# Technical Service Bulletin

**PRODUCT(S) AFFECTED:** **Falcon Ultra Automatic Carpet Extractor (Model No. #608350)**  
Machines Manufactured Before Serial Number: 608350-10012289 (5/03)

**SUBJECT:** Replacement Filter Kit #613981 Now Available.

## Replacement Filter Kit #613981

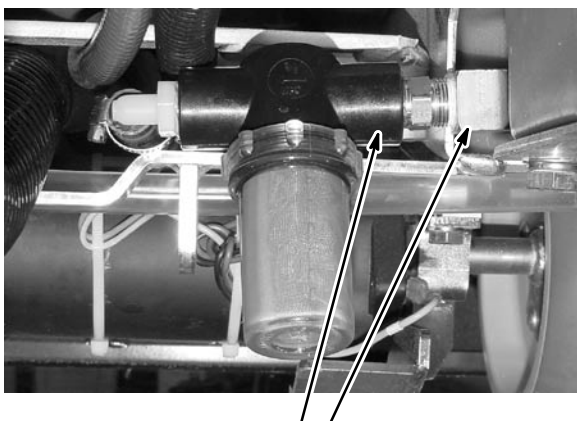
**PURPOSE:** The Replacement Filter Kit allows larger debris, such as plastic shavings, to flow into the filter which can then be easily cleaned out.

**Larger filter Inlet hole and fittings.**
